**Project Number:** SP2018-024  
**Project Name:** MEDICAL OFFICE BUILDING  
**Project Type:** SITE PLAN  
**Applicant Name:** PSA ENGINEERING, LLC  
**Owner Name:** ROCKWAY, PARTNERS LLP  
**Project Description:**

**RE: SITE PLAN (SP2018-024), MEDICAL OFFICE BUILDING**

## City of Rockwall Project Plan Review History

SHEET: C-01

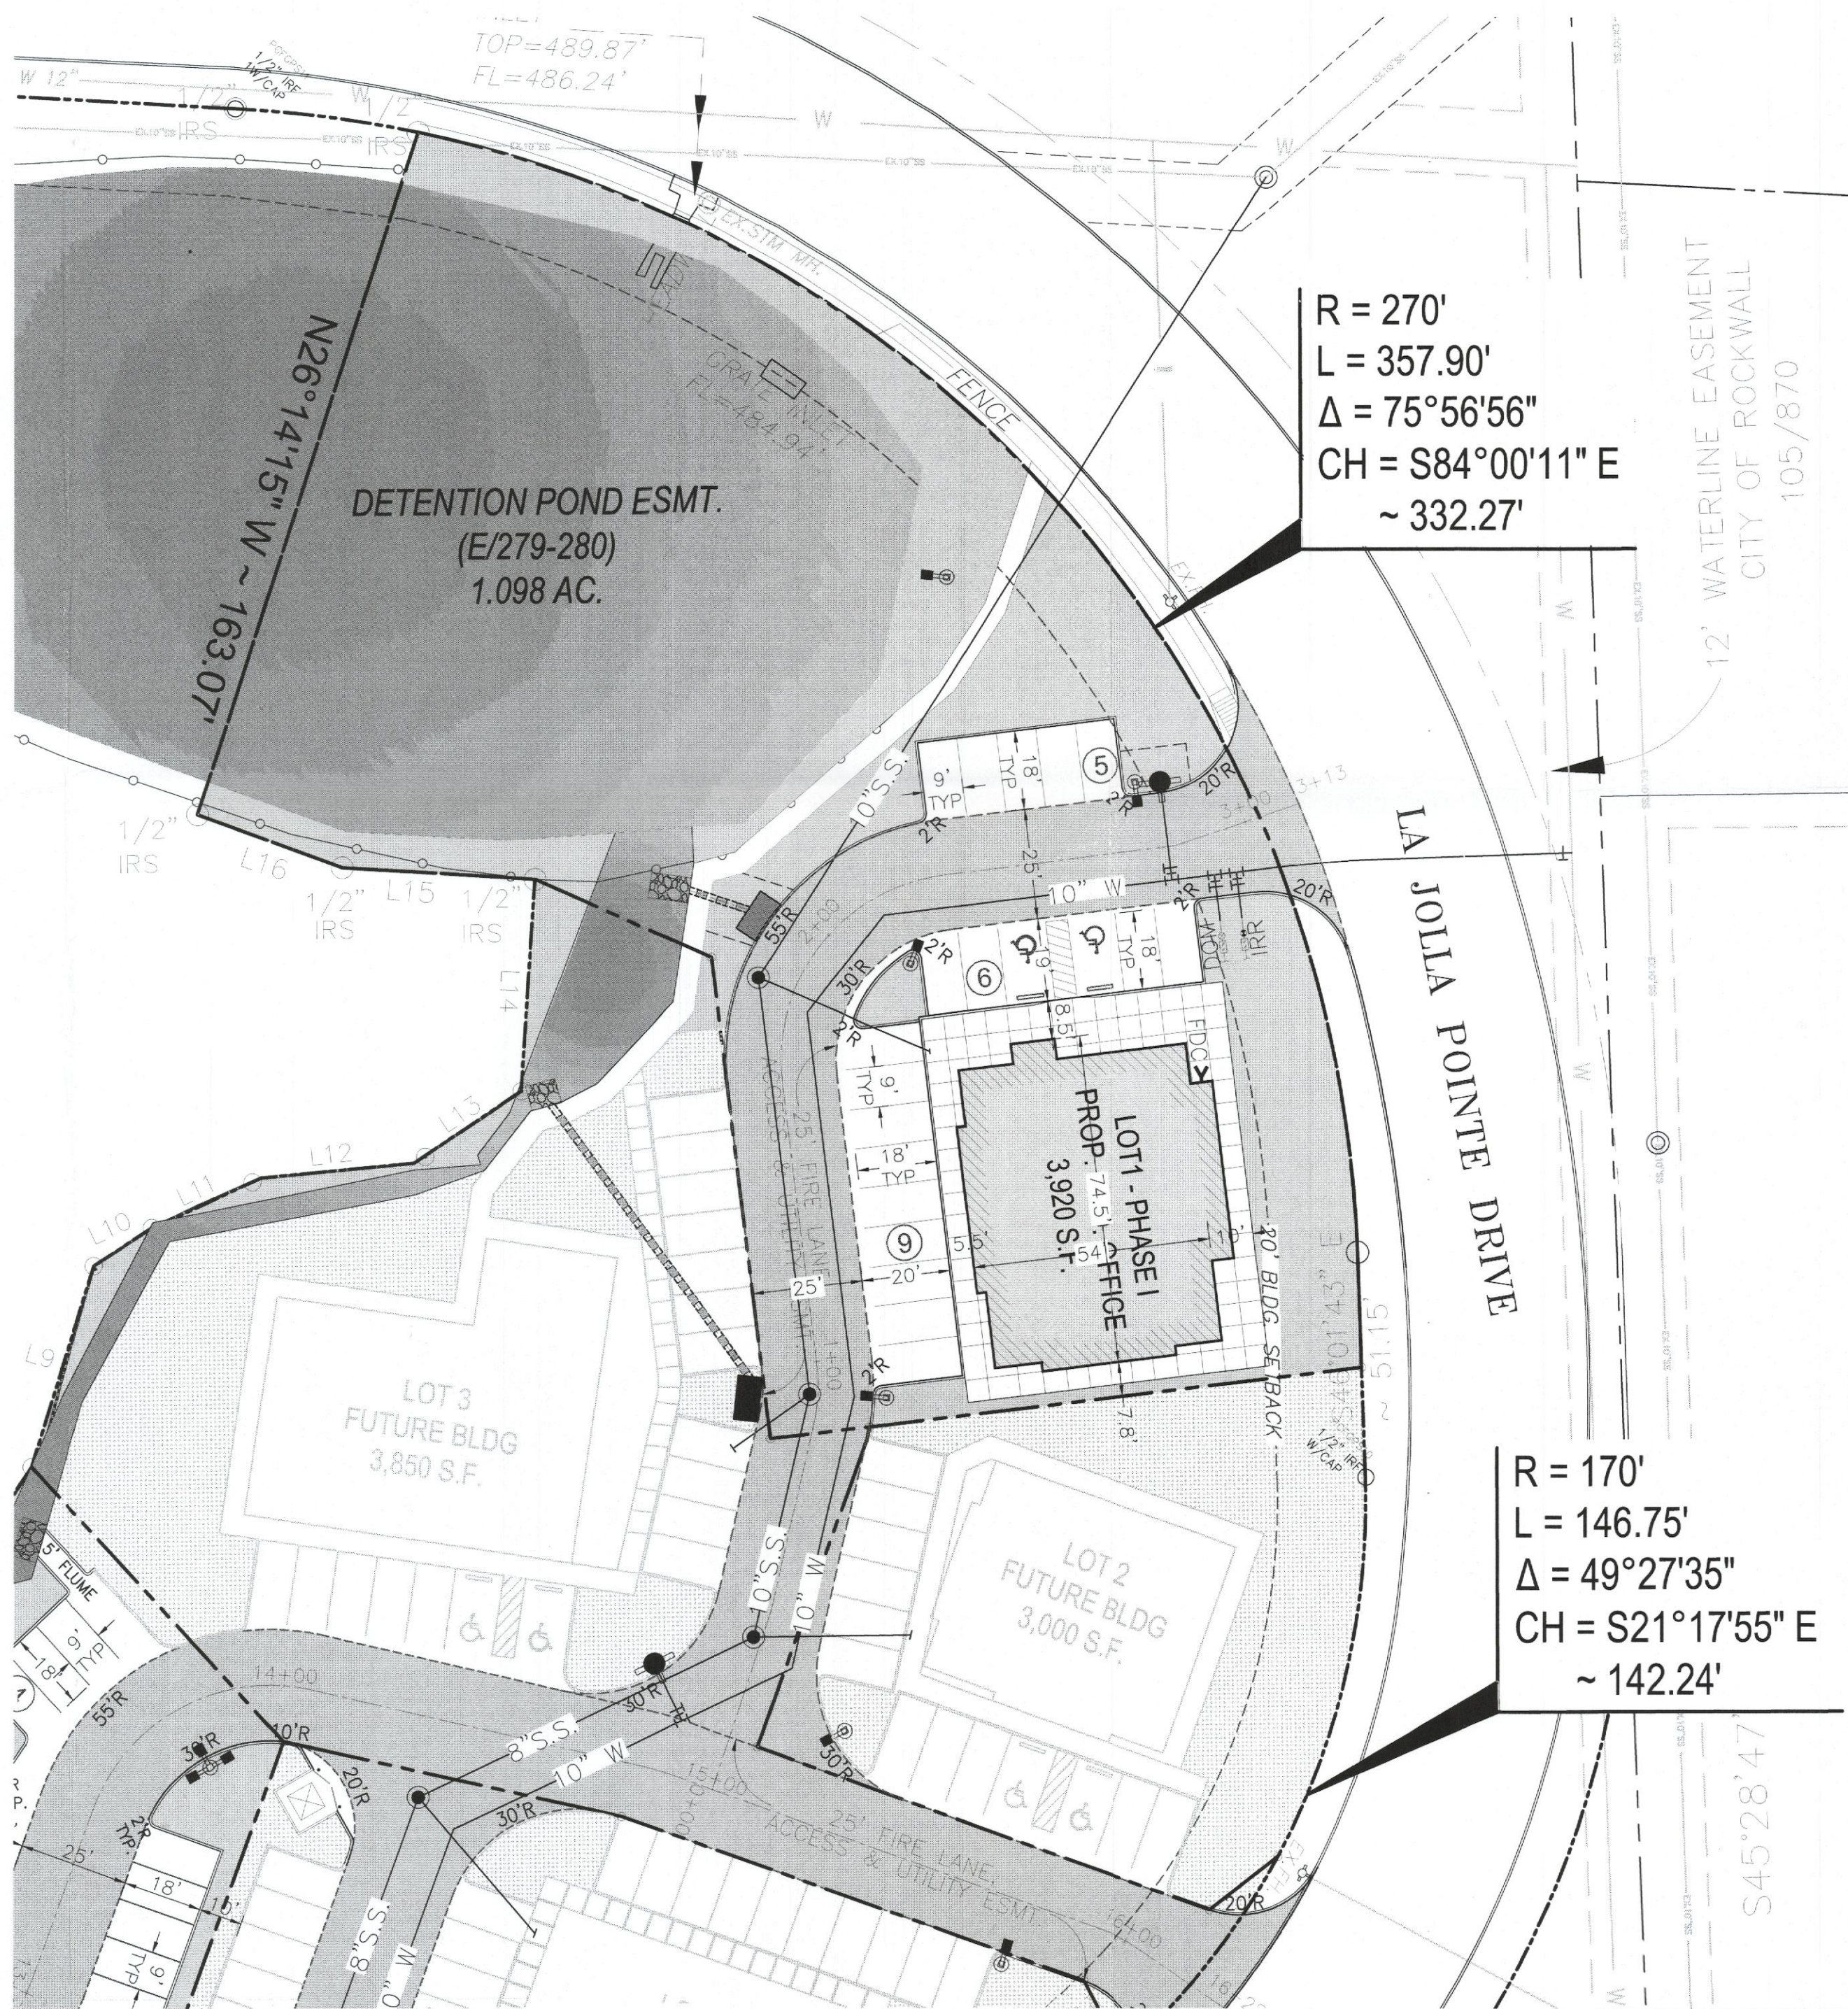
Type of Review / Notes	Contact	Sent	Due	Received	Elapsed Status	Remarks
<ol style="list-style-type: none"> <li>1. Relabel all firelane as '25-ft Firelane, Public Access &amp; Utility Easement as appropriate (i.e. if no utility within easement, do not include Utility).</li> <li>2. Where is the dumpster enclosure? As a note, it cannot face the street. Dumpster enclosure to include a self latching gate mechanism and gate to be opaque with walls to a minimum of 8-ft in height and the exterior materials matching the primary structure. Provide detail.</li> <li>3. Provide a minimum 10-ft landscape buffer along La Jolla Pointe Drive and label as such</li> <li>4. Where are the HVAC units? Are these ground mounted or RTU's? Must be screened from rights-of-way and open space. Provide detail.</li> <li>5. Side yard set-back for the south facing elevation must be a minimum of 10-ft unless this is a fire retardant wall. If fire retardant, check with fire department for specifications on meeting this requirement</li> </ol>

SHEET: L-01

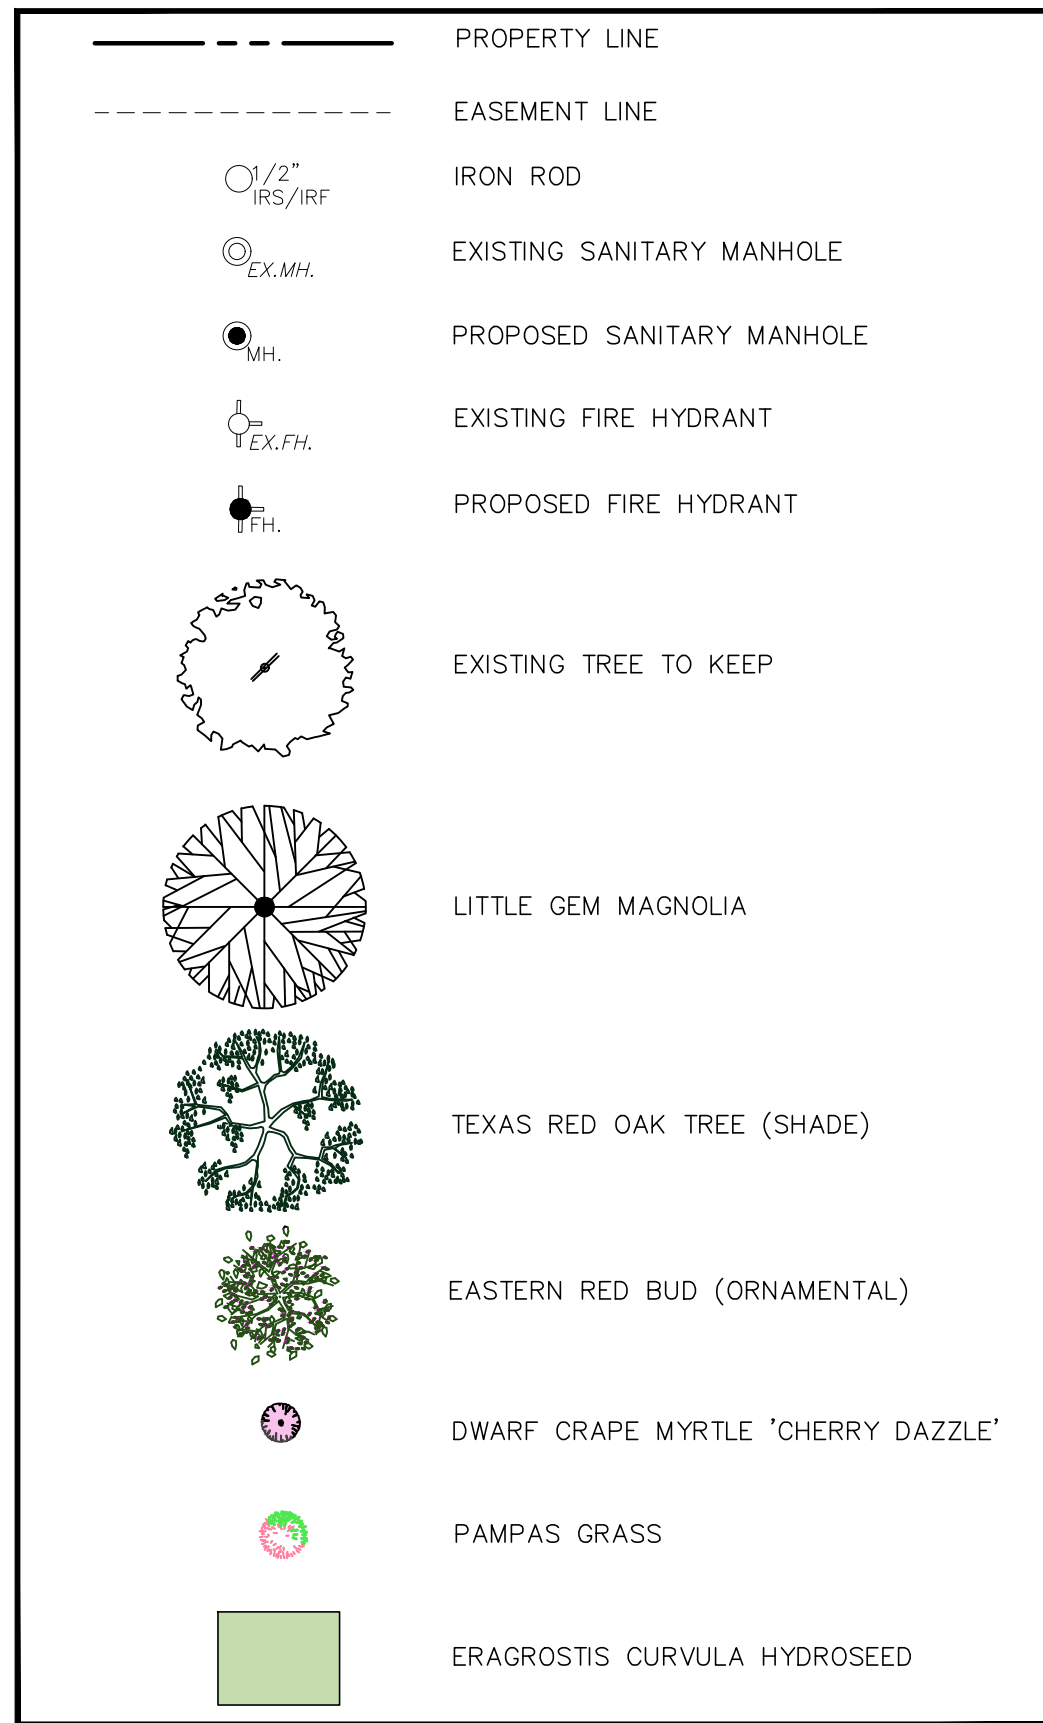
1. Provide a row of trees behind the perimeter of the building per SOV standards
2. Parking space not to be more than 80-ft from the trunk of a large tree. Provide minimum 3-inch caliper trees in islands at the rear of the property.

SCALE:	AS SHOWN
DESIGNED:	P55
DRAWN:	PSA
CHECKED:	P55
PROJECT NO.	21737.VPR
DATE:	JULY 13, 2018
SHEET:	C-05

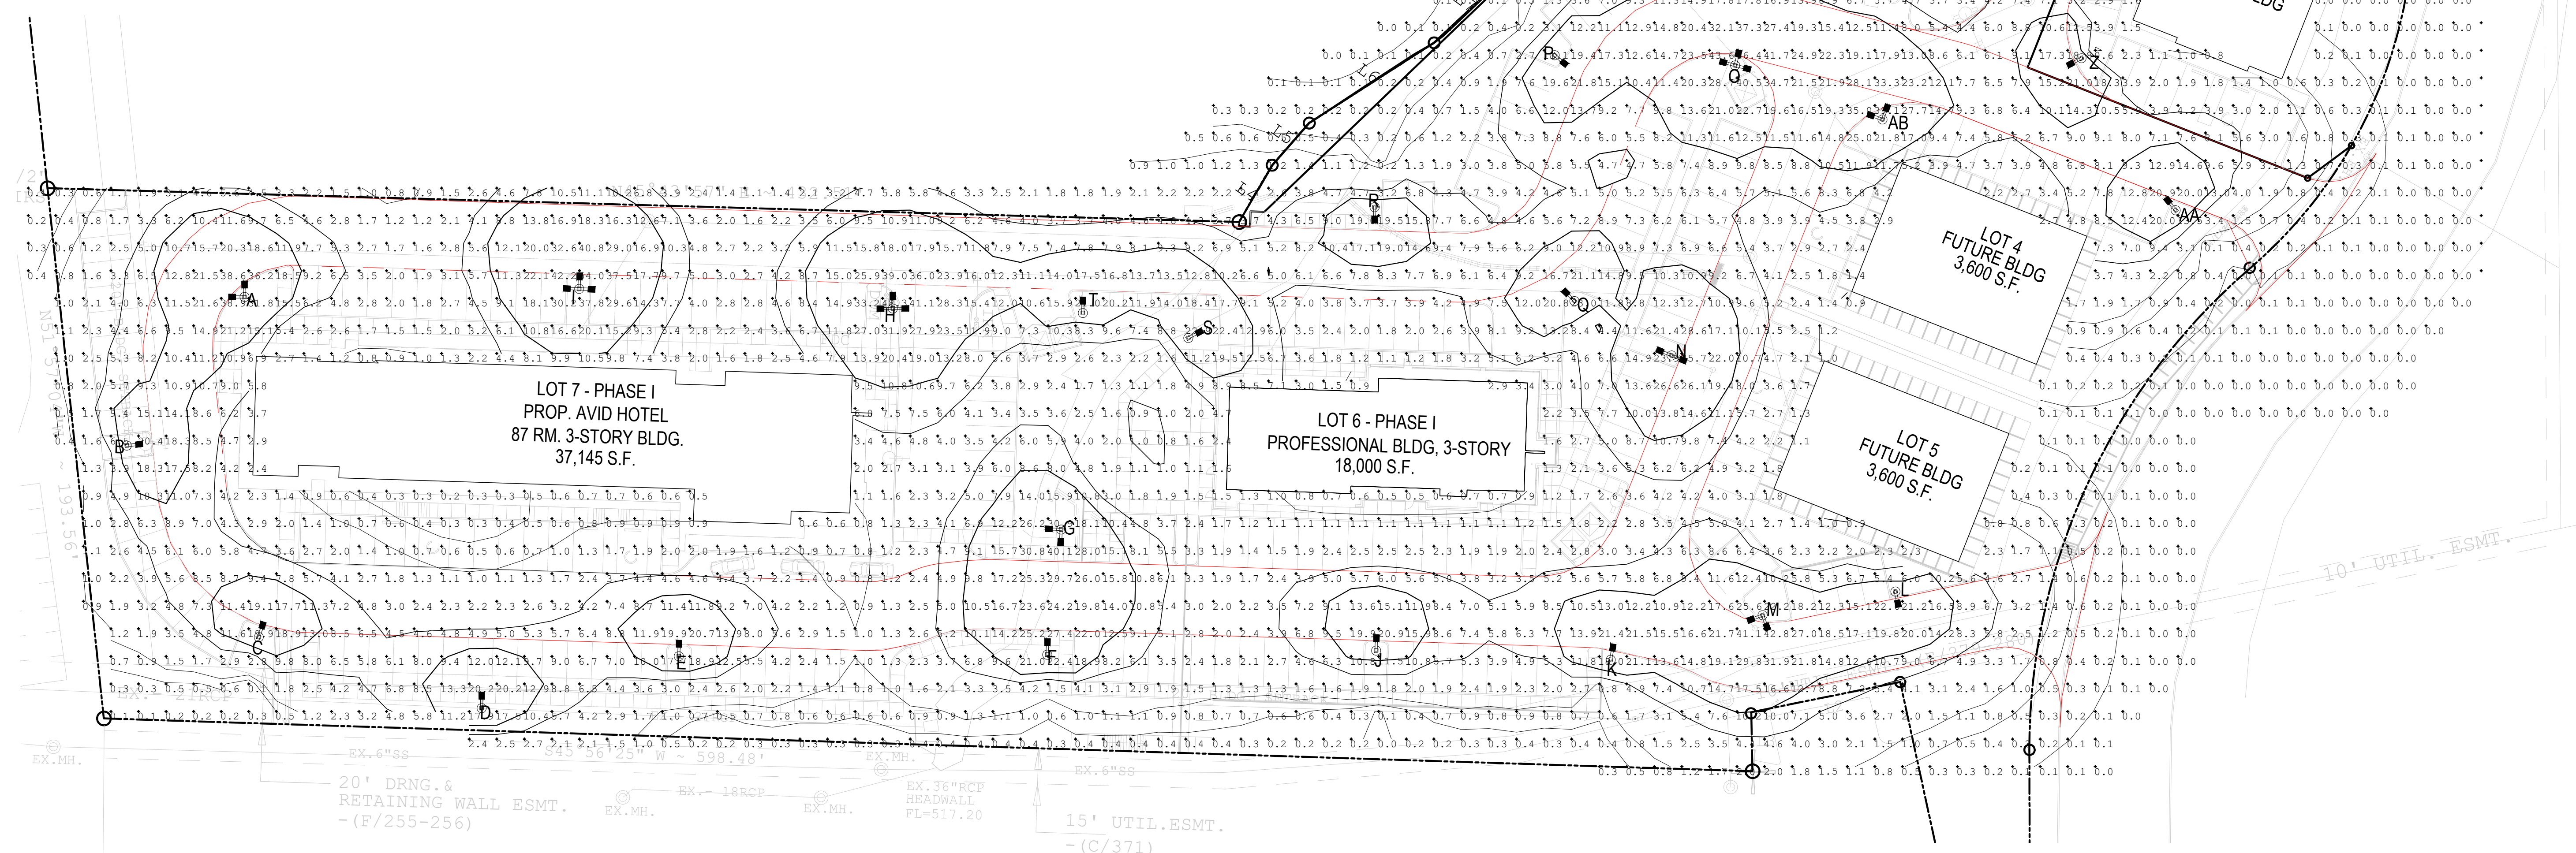
1. Provide a separate photometric plan for each lot/development.
2. High readings indicated on the overall plan, both at the property line and the internal lots. Review City standards under Section 3, Article VII Environmental Performance, of the Unified Development Code with re-submitting each separate lot plan
3. Exterior lightpole detail indicates pole to exceed the maximum overall height of 20-ft. Adjustment or approval of a variance required as indicated above
